Science Committee of the Edwards Aquifer Habitat Conservation Plan

Scientific Evaluation Report: Nonroutine Adaptive Management Proposal for the EAHCP VISPO

April 12, 2019

Figure 1 - What we are tempted by the limited data to see with default settings. Change looks big if the y-axis range is small.

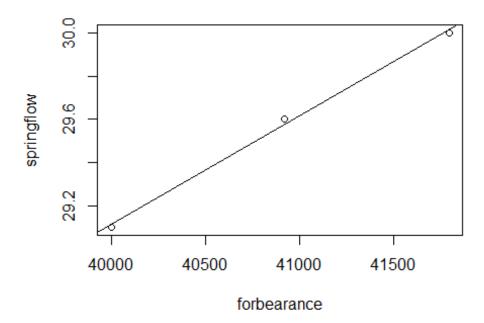
Unfortunately, that's not how we determine prediction error. We estimate measures of model fit for a calibrated model, using data that were held out of consideration during the calibration process. We don't chose a point on the validation simulation run where fit was "good" and use that as our estimate. We take a measure that represents the aggregate fit over the entire validation run.

We have three MODFLOW runs to evaluate, two done by the EAA staff with their model (Liu et al, 2017) and one by HDR (HDR, 2011).

Figure 2 - Now with the **90%** CI based on a t distribution with 2 d.f and se=8 cfs/. Last time I saw a table it seems the actual sd was higher than the 8 cfs used here. (Jim Winterle said "around ten" in the meeting March 27,2019.)

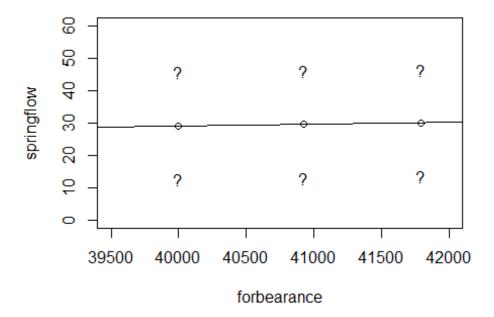
So we have three different forbearances that produce three springflow forecasts. Forecast standard deviation is about 8 cfs, sample size is 3 so d.f.= 2. Replot with 90% CI.

Calculate the $p(x \le 30 | model 2)$. The probability $p(x \le 30 | model 3) = 0.5$ because 30 is the center point of the forecast. Use these probabilities to form a ratio $p(x \le 30 | model 3)/p(x \le 30 | model 2)$. The calculations indicate only a small increase in the probability that mean spring flow during DOR is ≥ 30 . Further, the actions under the third model will only lower the probability from 0.525 to 0.50.

Maybe the error distribution of the EAA MODFLOW model is not a *t* distribution, as the quote above mentions a considerable bias. Maybe we shouldn't settle for a 50% probability of "success", but that's for another day.

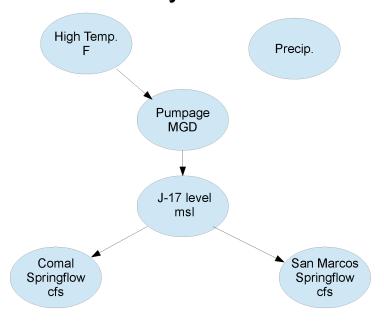
It may be impractical to run the MODFLOW model enough times to have multiple MCMC chains converge, a problem that gets worse as the number of parameters increases. It is possible (Lamon, 2015) to take advantage of the relationship between flow and J-17 elevation to develop the desired sampling distribution for the mean springflow resulting from DOR conditions. Such a *probability network model* could be used with the DOR scenario inputs for this purpose.

Figure 4 - Dynamic Linear Model predicting daily average Comal springflow as a function of a constant trend and daily average J-17 elevation predictor variable, from Lamon, 2015. This model has a median absolute deviation (MAD) of 1.52 cfs.

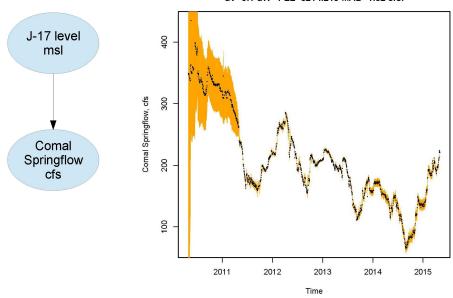
With millions in VISPO payments at stake riding on differences in forecast means of less than 1 cfs, and long term investments in modeling to develop those forecasts, it seems as if we'd be closer to a finished decision tool than a 30-40 cfs bias and 8 cfs mean squared error indicates. This is not meant as an argument against the changes to VISPO. Rather it is meant as an argument for investment in quantification and reduction of uncertainty in the springflow forecasts, and to offer my opinion on a logical course of action by which it may be achieved.
